MPE720 Ver.7.97 Version Up Information

1.1 Ver.7.97 Version Up Information

■ 3 Optional Slot Base Unit

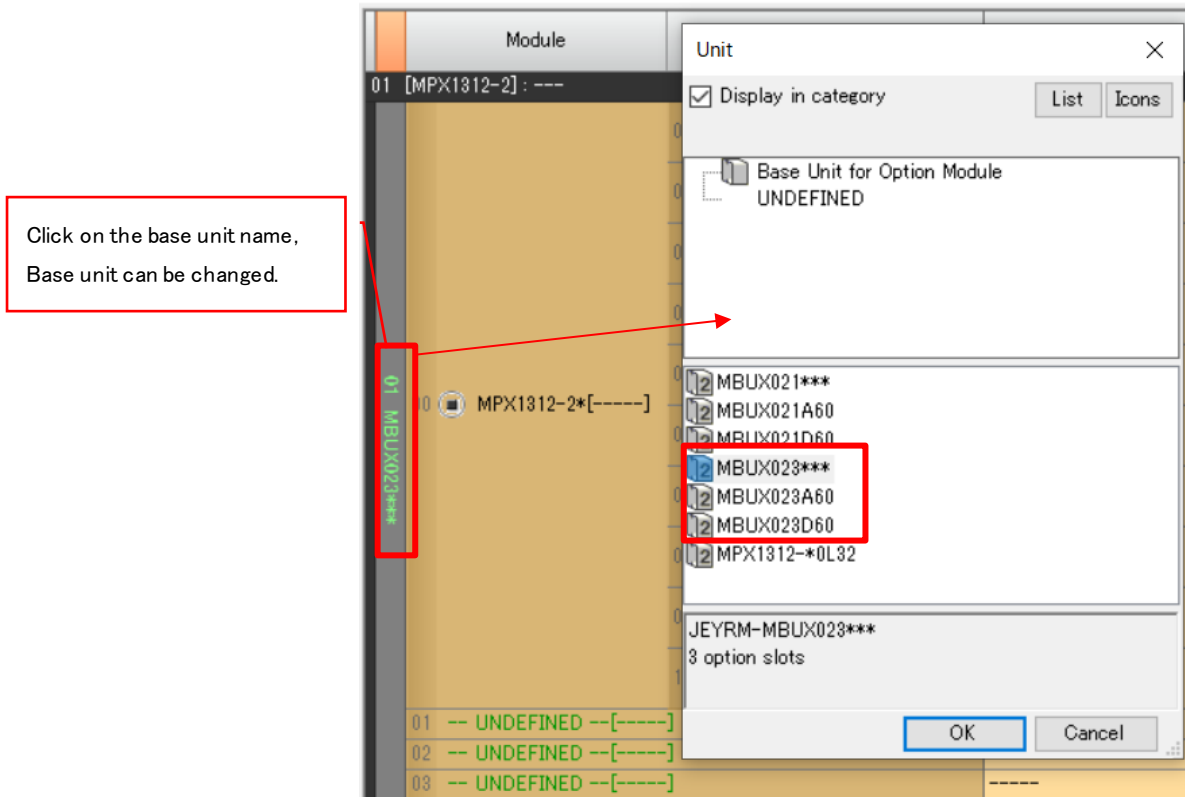
No. 2 MPX1312-2 Added support for 3 optional slot base units.

In the module configuration definition, you can configure the base unit of the MPX1312-2 with three option slots. There are three types of base units that can be selected.

- MBUX023A60 (Power supply type: AC100/200V Input 60W)
- MBUX023D60 (Power supply type: DC24V Input 60W)
- MBUX023*** (Power supply type: not specified)

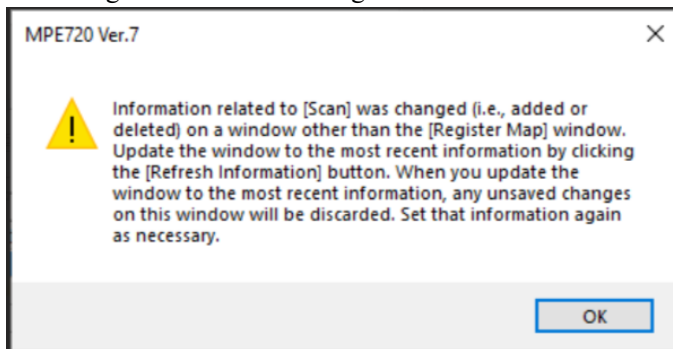
- When "Search in project" or "Replace in project" is executed on a multi-scan model, corrected the notation of the scan name of the message that is displayed in the output window.

Before Modification	After the fix
Scan20	Start
Scan30	Interrupt
Scan0	H
Scan1	L
